Agenda Supplement

Applicant Submitted Information

Information Submitted by the Public

SK-1

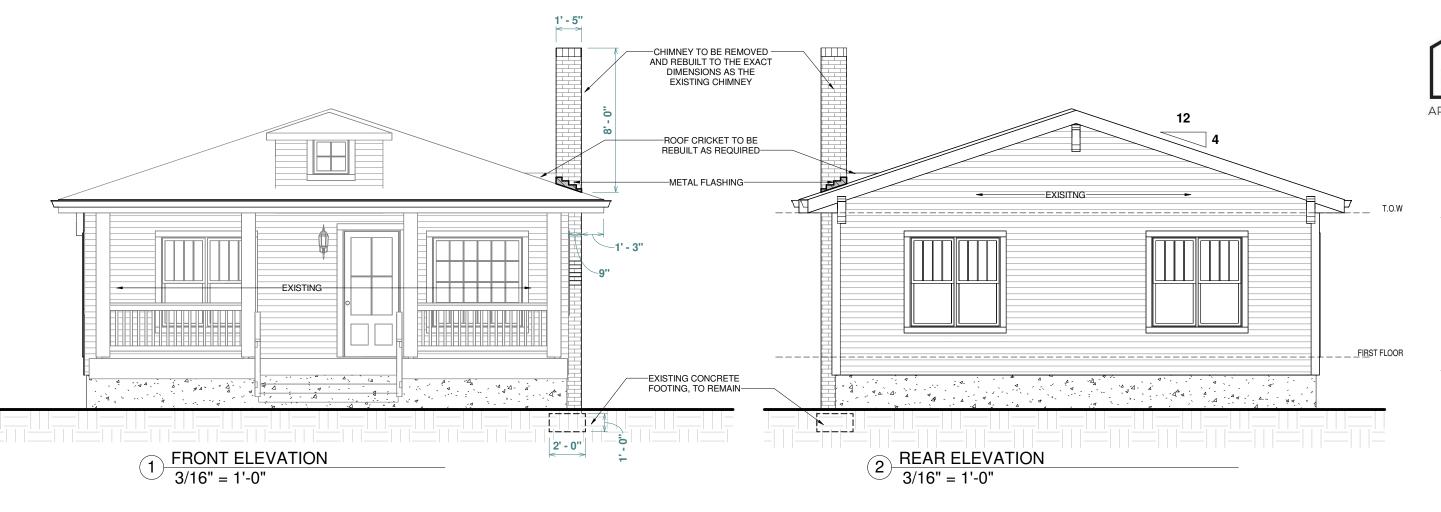
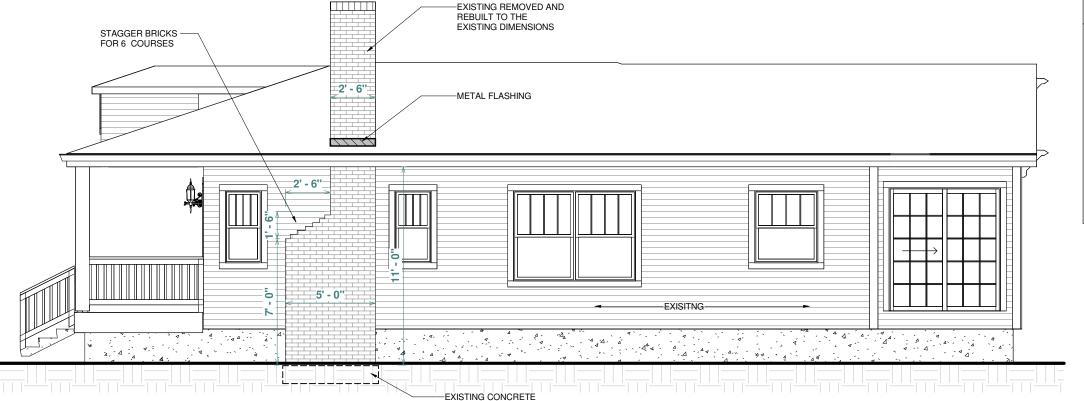
REMOVE THE FULL BRICK MASONRY CHIMNEY, AND REPLACE WITH NEW CHIMNEY FOR APPEARANCE ONLY.

1210 Dilworth Road

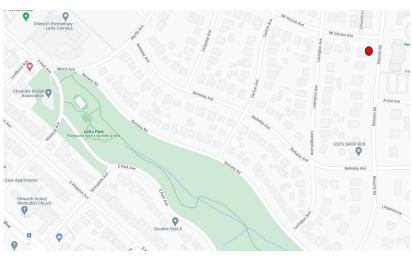
Are there other examples of asymmetrical porch roofs supported by in Dilworth?

STREETSCAPE **ELEVATIONS**

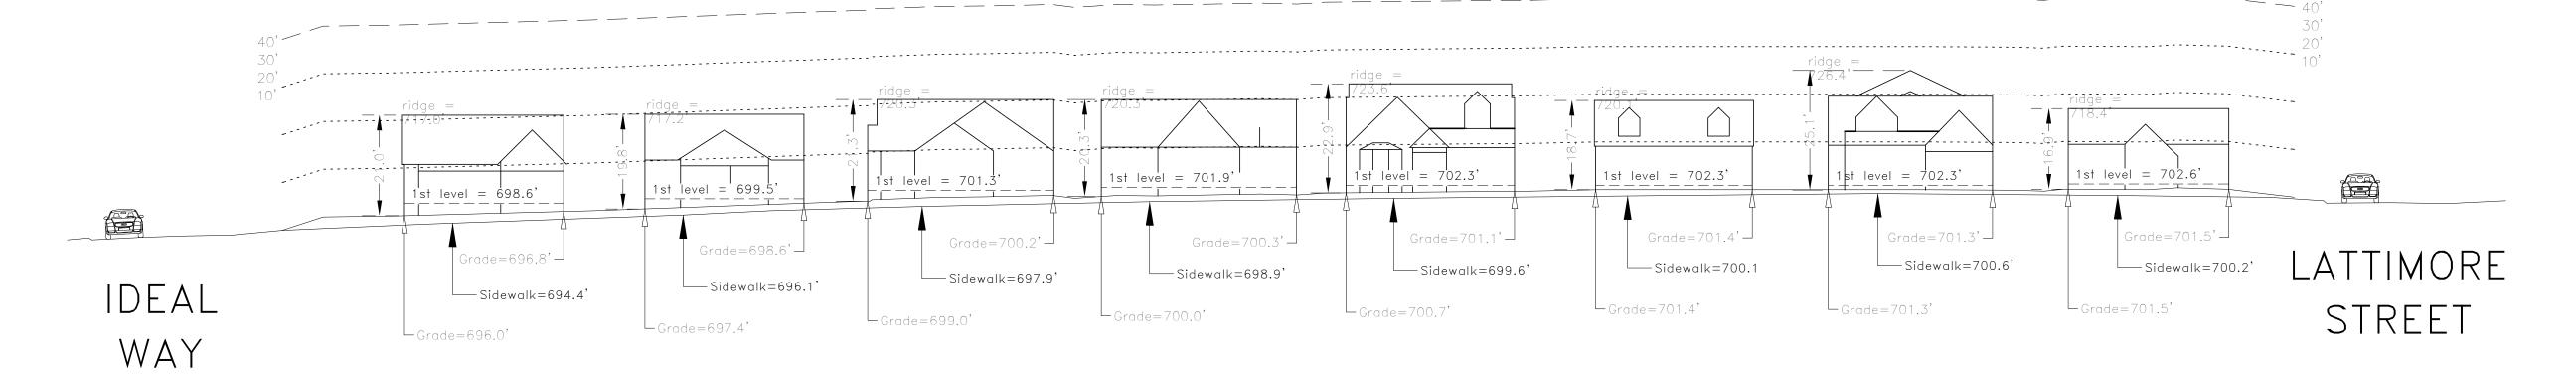
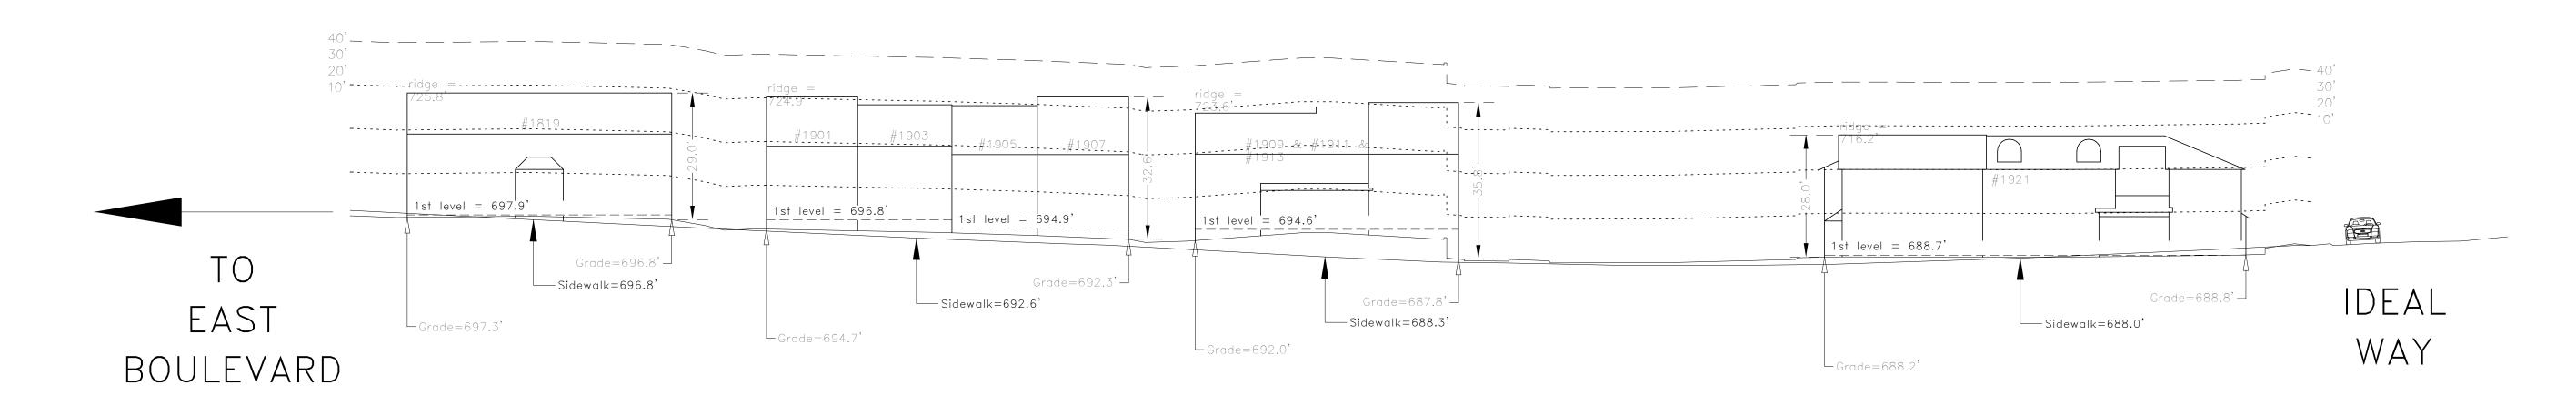
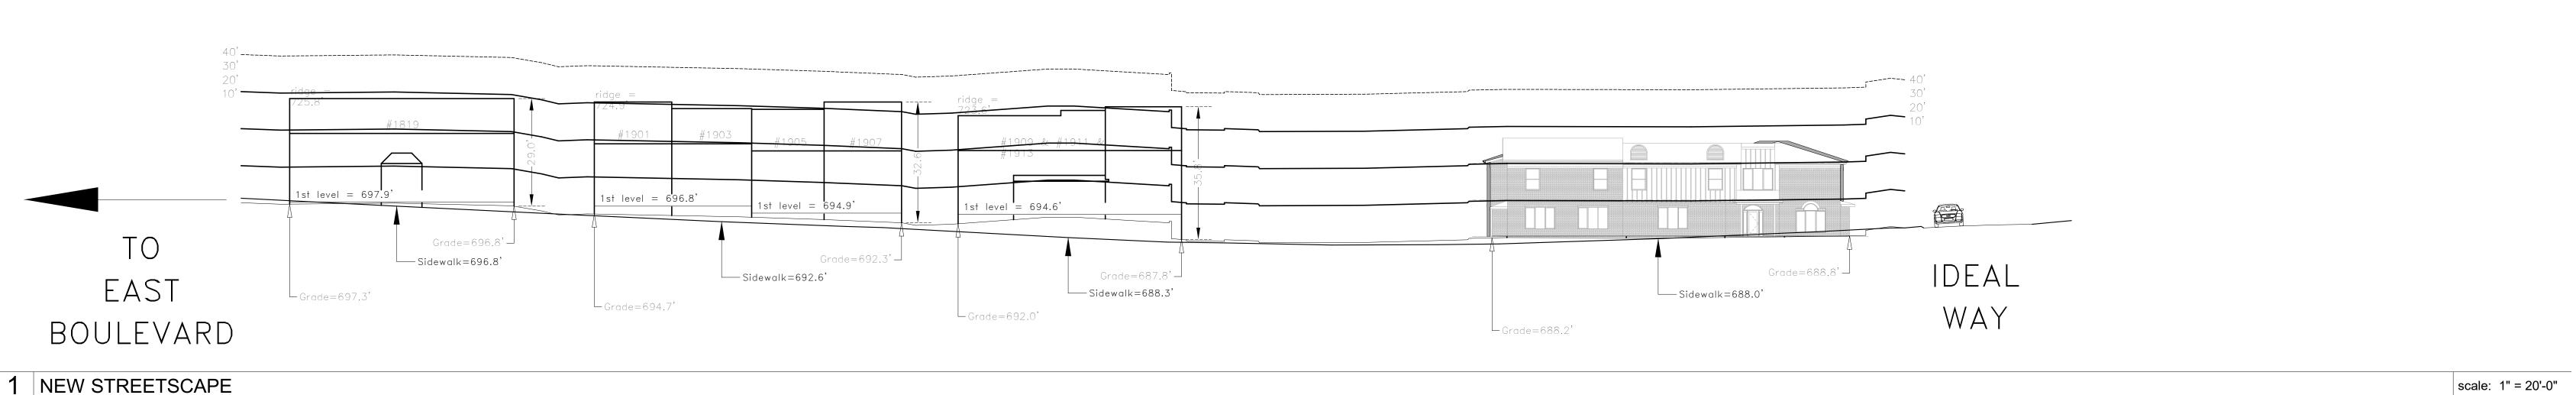
The subject project does not adequately address massing and complexity of form to fit in with the adjacent historic buildings. The east and west elevations of the new building are simple, flat surfaces without any complexity. The east elevation along Kenilworth is also flat with minimal rhythm provided by a change in exterior finish. None of the massing mimics any of the form from adjacent historic buildings with projecting bays, dormers, etc. The building is nothing more than a simple, plain box you would expect from a suburban motel.

The subject project does not include any design elements that provide a human scale for the building. The building should include elements typical to the surrounding context such as porches or one story projections to bring the building into scale with the surrounding neighborhood. None of these elements are included in the current design.

The subject project does not provide spacing between the existing and new structure along Ideal way that matches the historic pattern in the immediate surroundings of the new construction. There is approximately 10' between the new and existing buildings - much less than between other buildings in the immediate area. This adds to the massing and scale of the project from Ideal Way making the building spacing unlike the surrounding historic properties.
